Our Ref: K-2578-IRR-001
Your Ref: OP3043/2019
Date: 31 May 2019

Re: Information Request – Operational Works – 12 Crawford Street, Mossman

Response

<p>KFB ENGINEERS ABN 28 351 246 509</p>	Civil & Structural 20 Scott St, Cairns PO Box 927, Cairns Q 4870 P: 07 40521700 F: 07 40521634 E: email@kfbeng.com.au	JOB No: K-2578
	SHEET: C12G	SCALE: 1:500 (@A1)

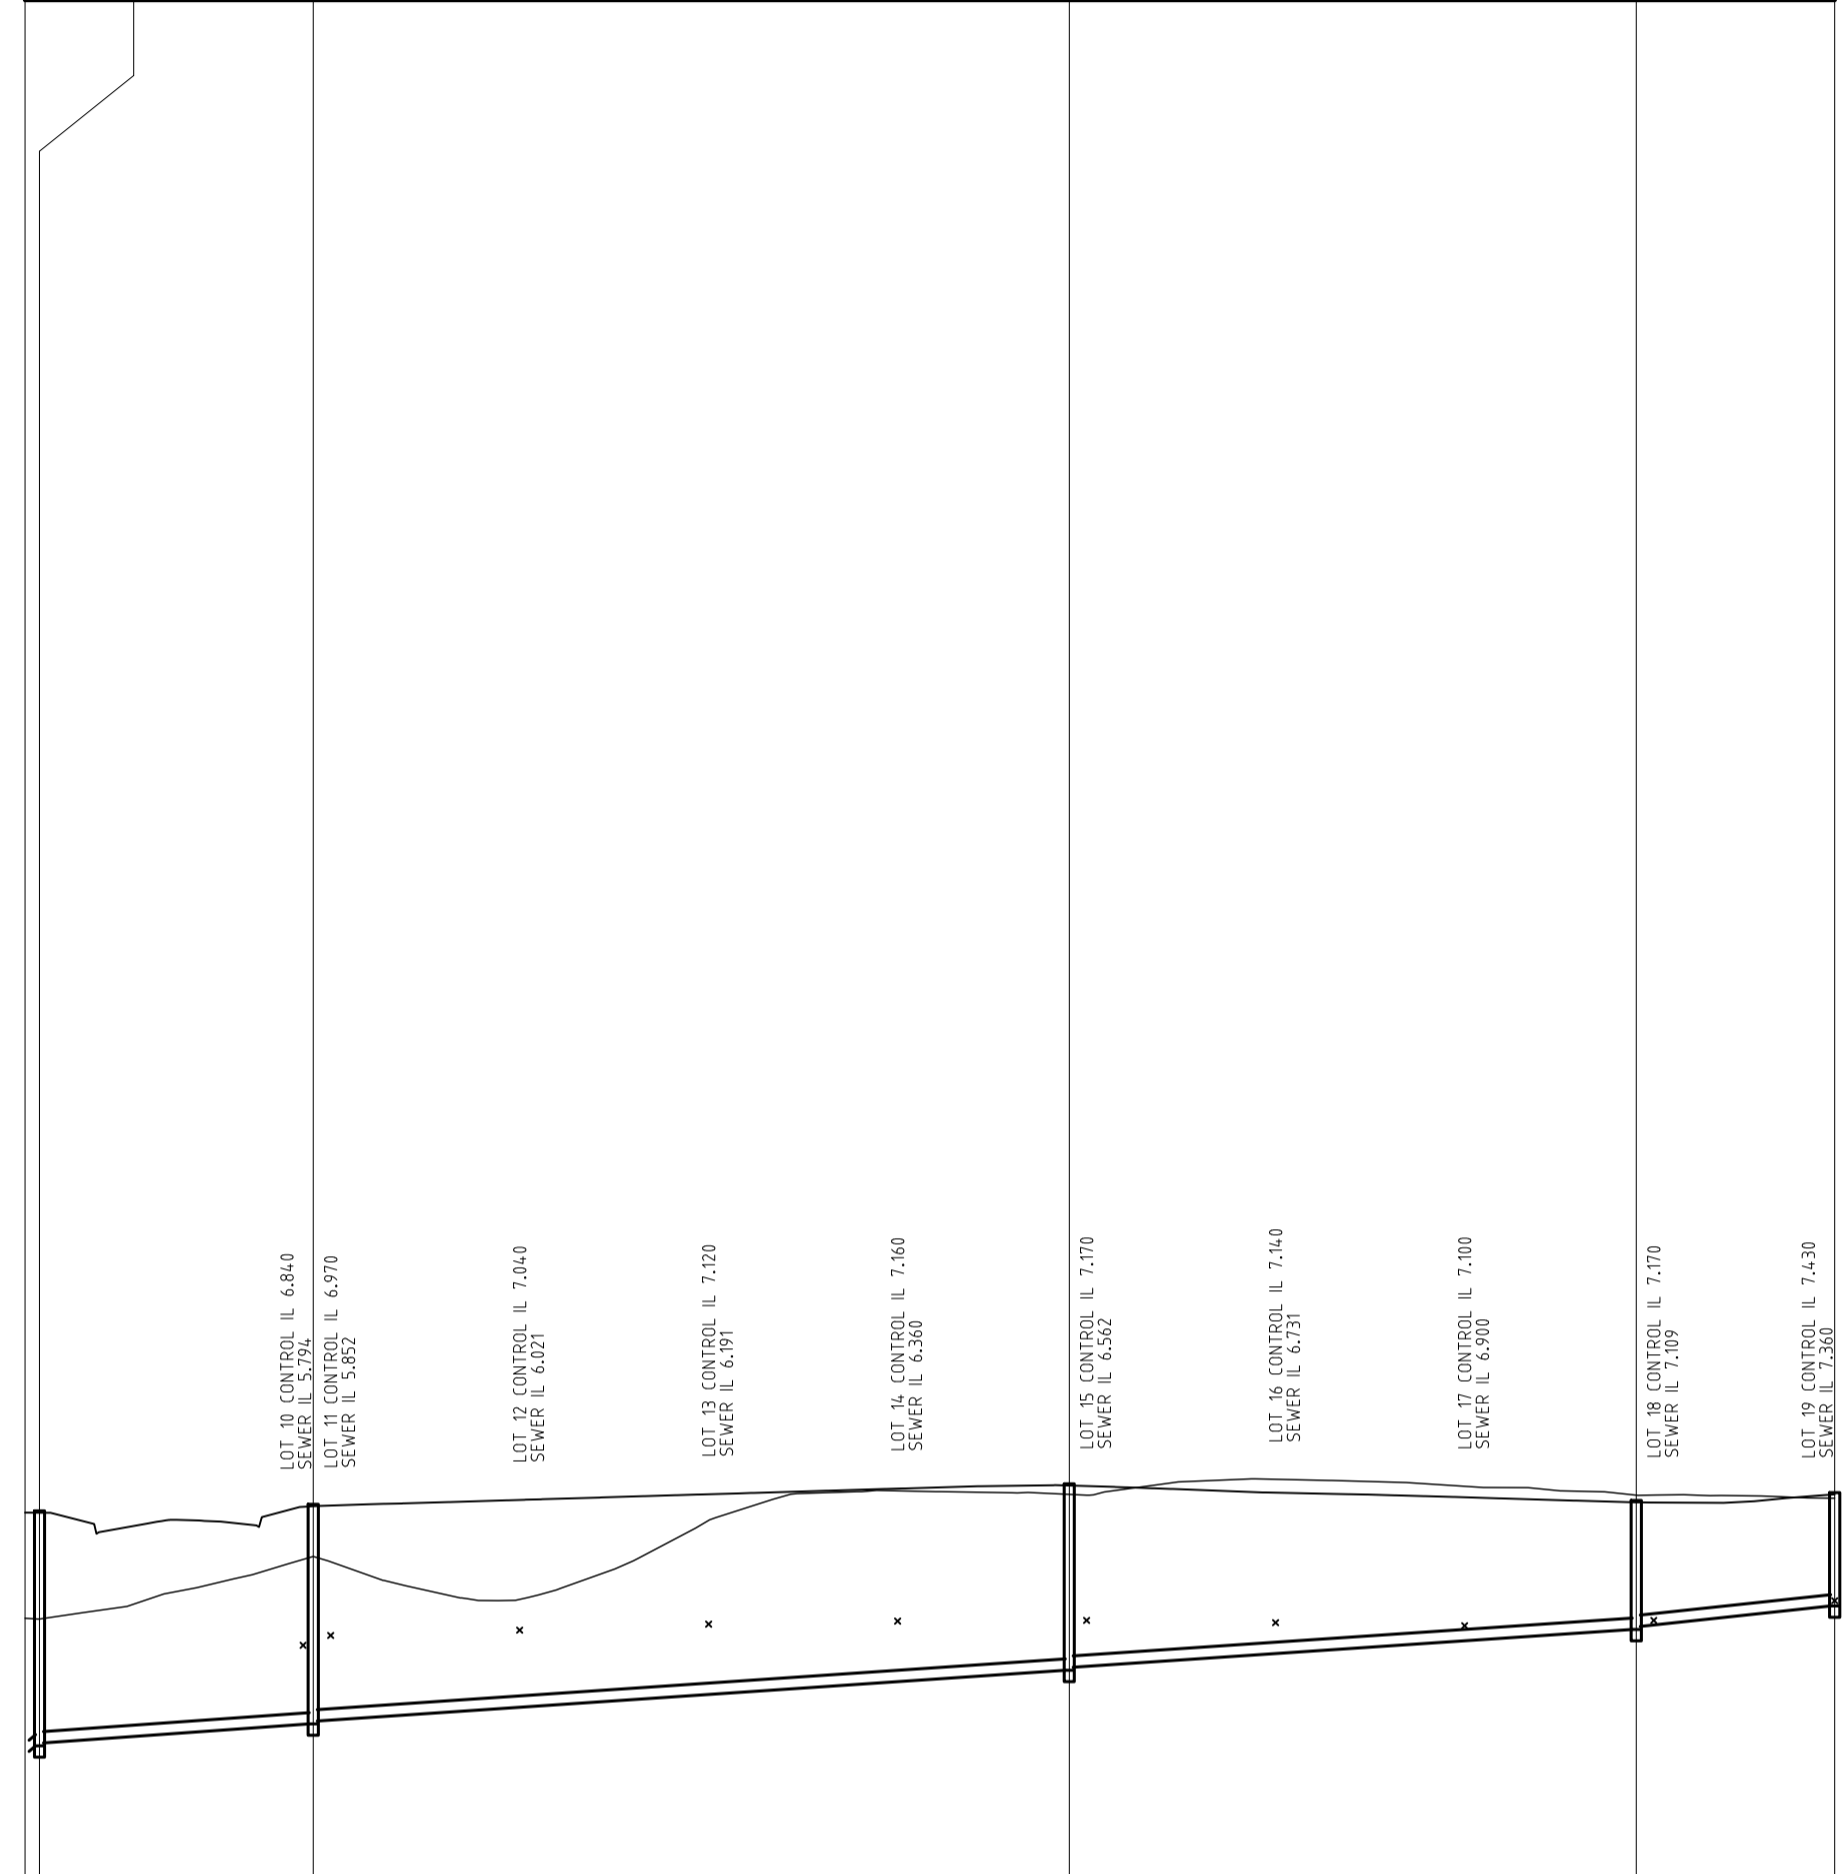
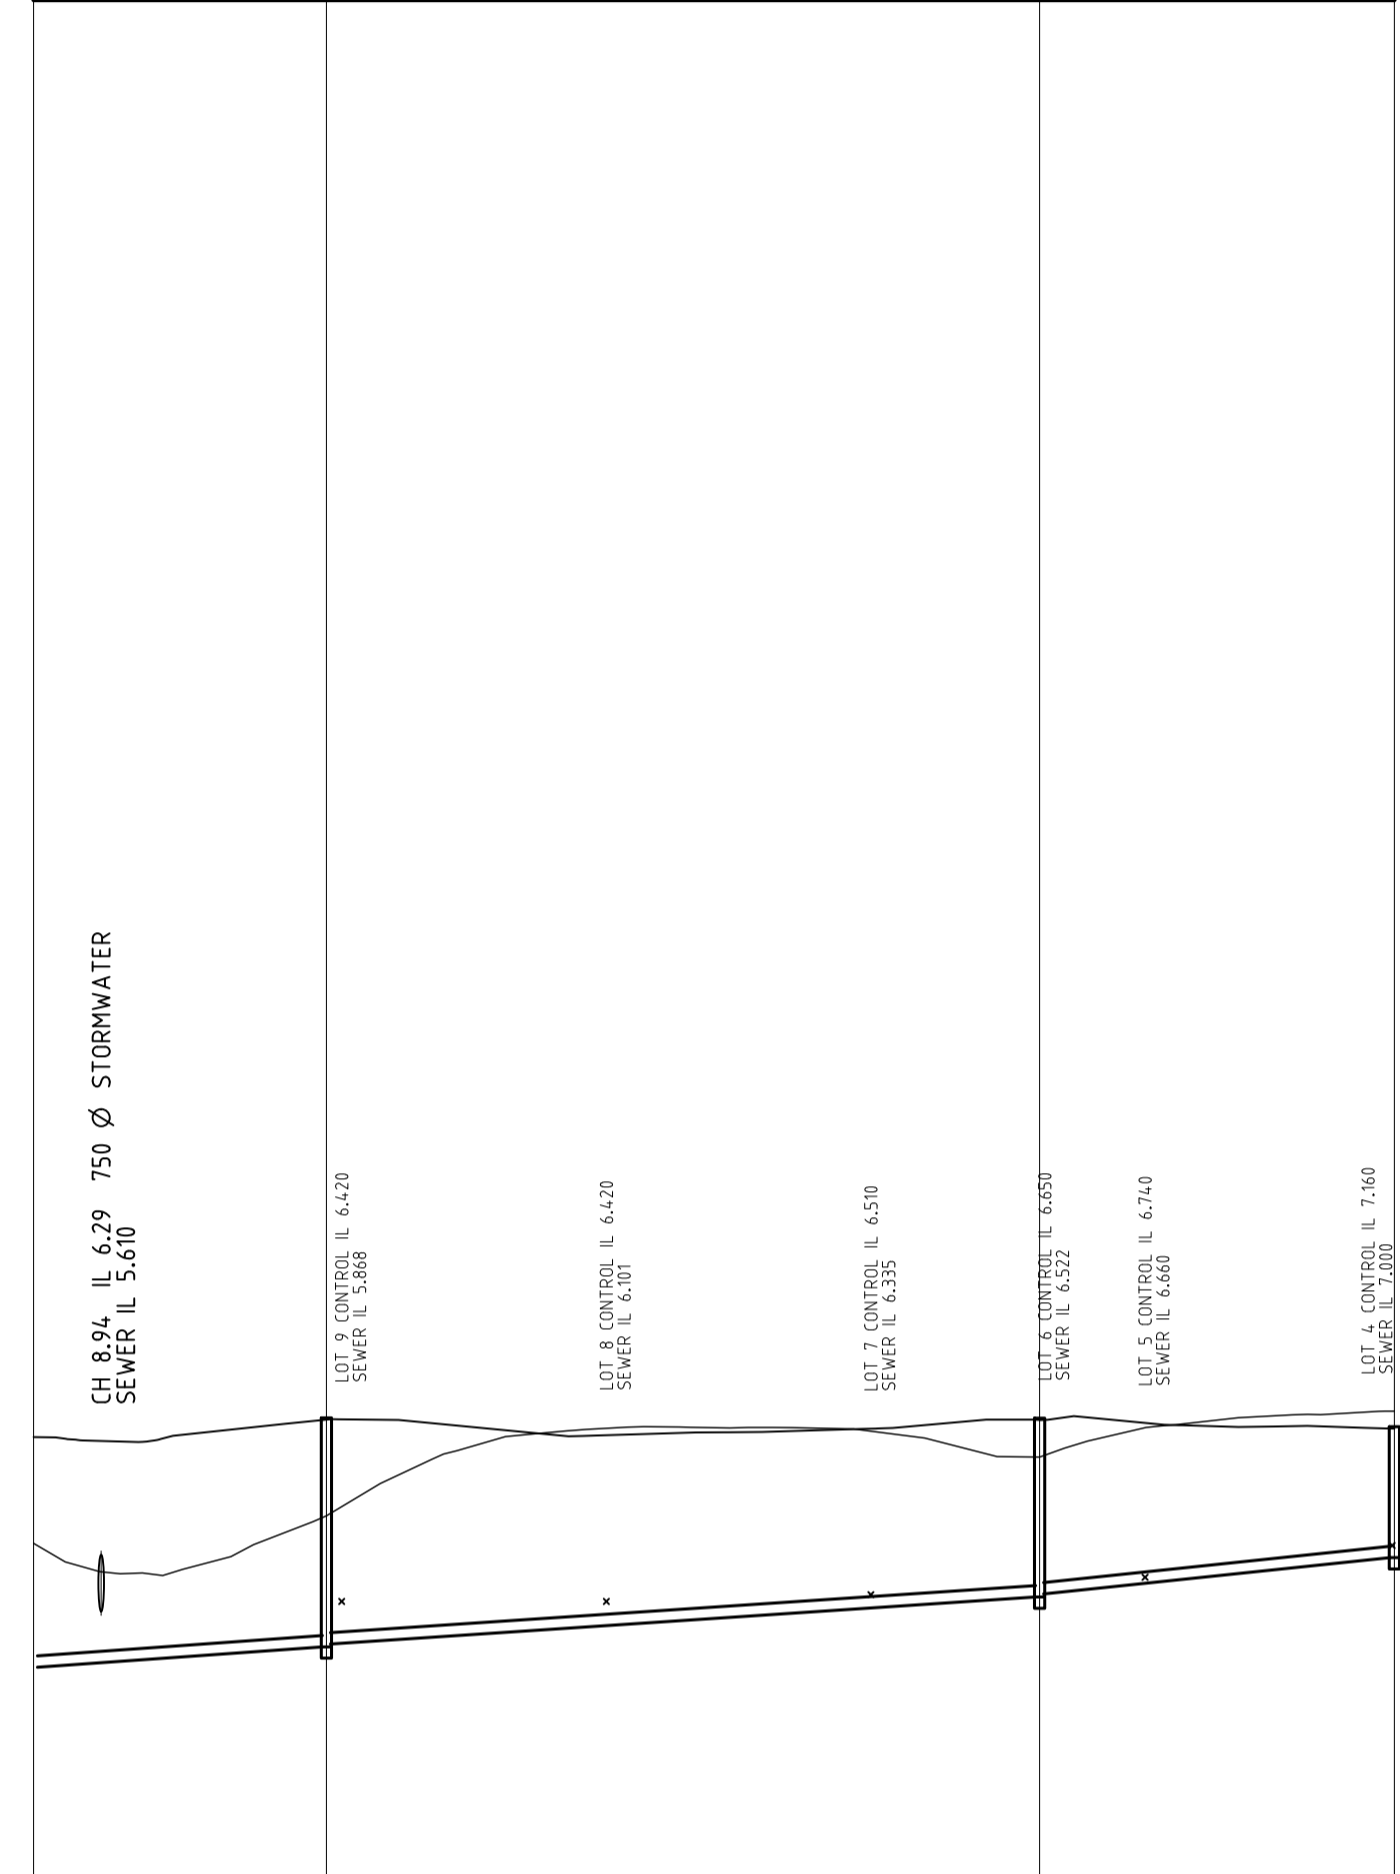
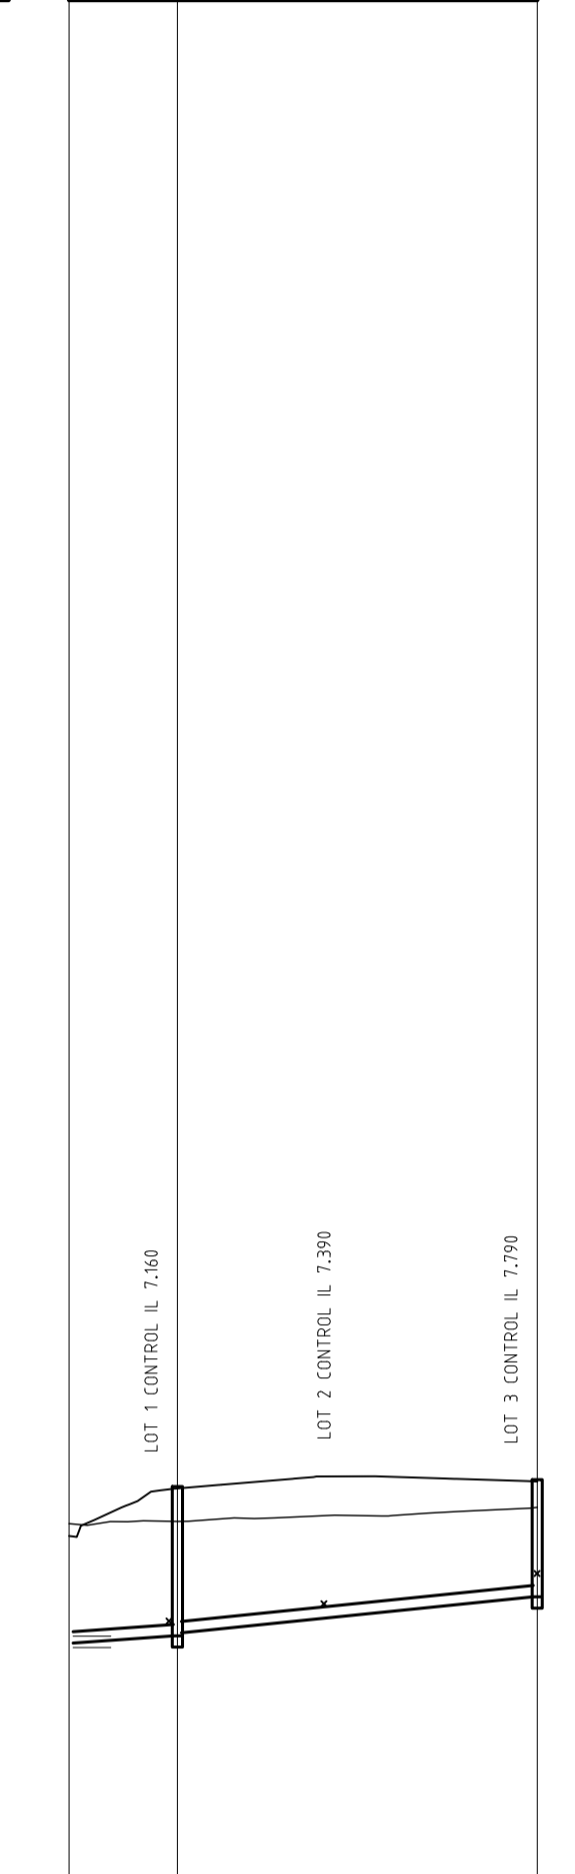
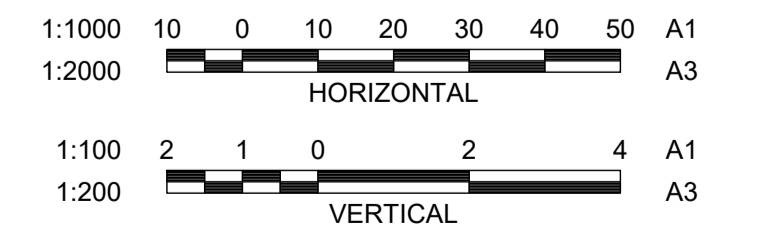
- 30. Confirm the sewer property connections elevations calculated (for sewer grading) are deep enough to service the entire lot using the property drain design criteria set out in FNQROC D7.14, clause 12. Provide an amended sewer longitudinal section if necessary.**

- 31. With regard to the photo below of the receiving manhole detail how the new connection relates to the existing stub and the proposed new pressure main. Assessment of the capacity of the existing manhole for pump flows is required.**

Drawing K-2578 Sheet C12 details the sewer lot control calculation for each lot. The lot control calculation is detailed on Sheet C12.

Sheet C12 – Sewer Reticulation Layout - has been amended such that the rising main discharges into manhole 2/4 and gravity line 4 discharges into existing manhole EX4.

SHEET: **C14** | **D**

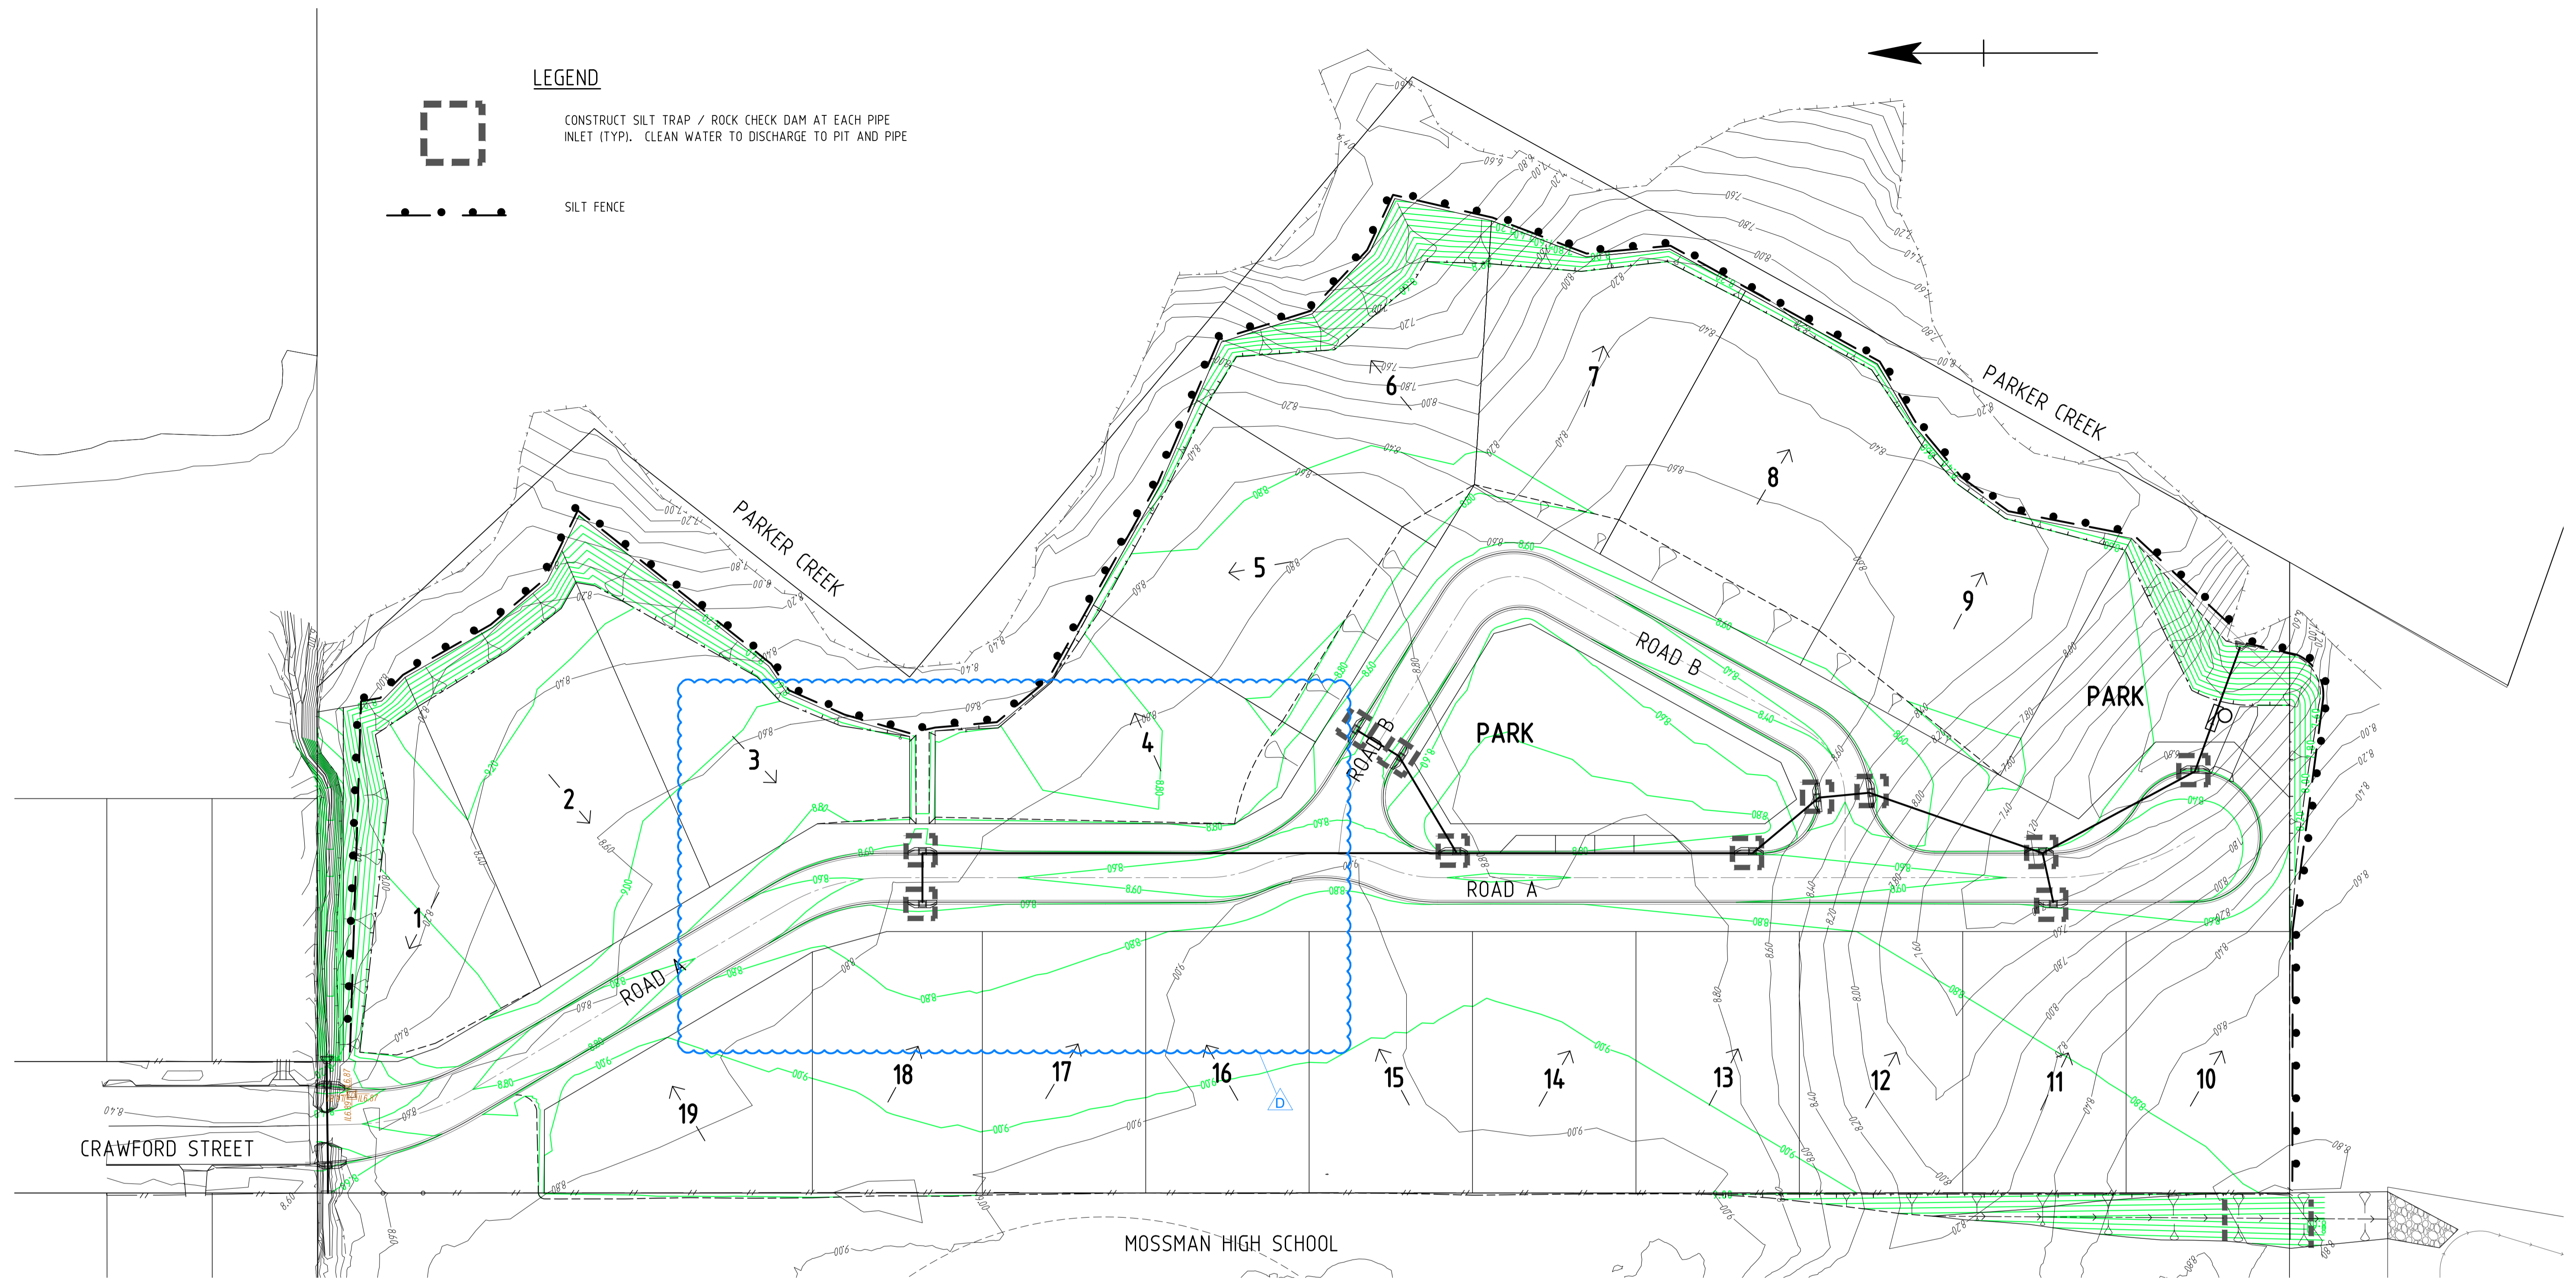
- 25. Valves are to be installed on the leg of all tees. Additional valves should also be installed to one or both sides of tee junctions as per FNQROC D6.13. Provide an amended Water Reticulation Plan.**

- 26. The proposed hydrant locations on the western side of Road A are more than 80m apart and do not comply with FNQROC D6.12 (ie between the existing hydrant in Crawford Street and Lot 12/13 boundary). Change the hydrant locations or provide additional hydrants so that hydrants are no more than 80m apart. Provide amended Water reticulation Plan.**

- 27. Please amend the Water Reticulation Plan to include the proposed location of water service connection for each lot.**

Drawing C14 amended to provide valves as requested.

Drawing C14 amended so that hydrant location complies with FNQROC D6.12.

Drawing C14 amended to show the location of water service, in accordance with Douglas Shire Council specific requirements, for each lot.
